Strathmore Square, Preliminary Plan No. 120190180

Completed: 05/24/19

Description

Figure 3: Preliminary Plan

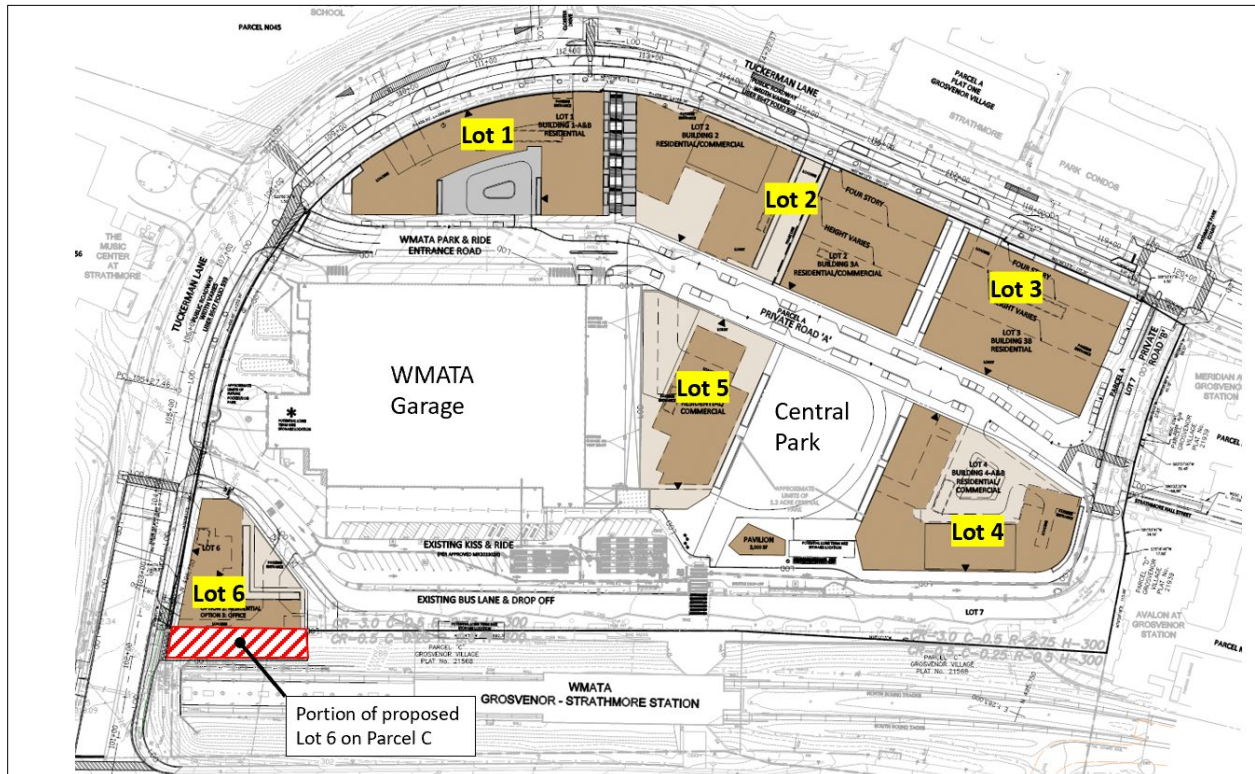
40. Prior to submittal of the Certified Preliminary Plan, the Applicant must make the following changes:
 - a. Show resolutions and Agency approval letters on the approval sheet(s).

- b. Show interim streetscape improvements along the Property's Tuckerman Lane frontage.
 - c. On Sheet PP-1:
 - i. Revise footnote 2 under Density Calculation to, "Additional density allowed per Zoning Ordinance, Section 4.5.2." Delete the rest of the footnote;

- ii. Remove note in Public Open Space table;
 - iii. In Building height note, replace "Additional 12 feet permitted" with "An additional 12 feet may be allowed under Section 59-4.5.2.C.7; and

- iv. In Parking Calculation Summary table, delete the second sentence of Note 7.
 - d. On Sheet PP1A, change the cross section for Tuckerman Lane between MD 355 North and the building on Lot 6 to show an eight (8)-foot-wide shared-use path with a five (5)-foot-wide buffer.

- ii. Show that the right turn lane from westbound Tuckerman Drive onto MD 355 will remain and only the channelized right-turn movement will be removed.
 - iii. Show the alternatives for a bicycle connection between the Property and the shared use path system north of The Music Center at the Strathmore and add the following note: "Final location of shared use path north of the Property to be determined at subsequent Site Plan"
- f. Work with Staff to clarify the phasing for transportation improvements not currently shown on the Phasing Exhibit, including but not limited to:
 - i. The full extent of the shared-use path, widened sidewalks, two-way separated bike lanes, crosswalks, and all intersection improvements along Tuckerman Lane;
 - ii. Improvements to the WMATA busway; and
 - iii. The intersection of Rockville Pike and Tuckerman Lane.
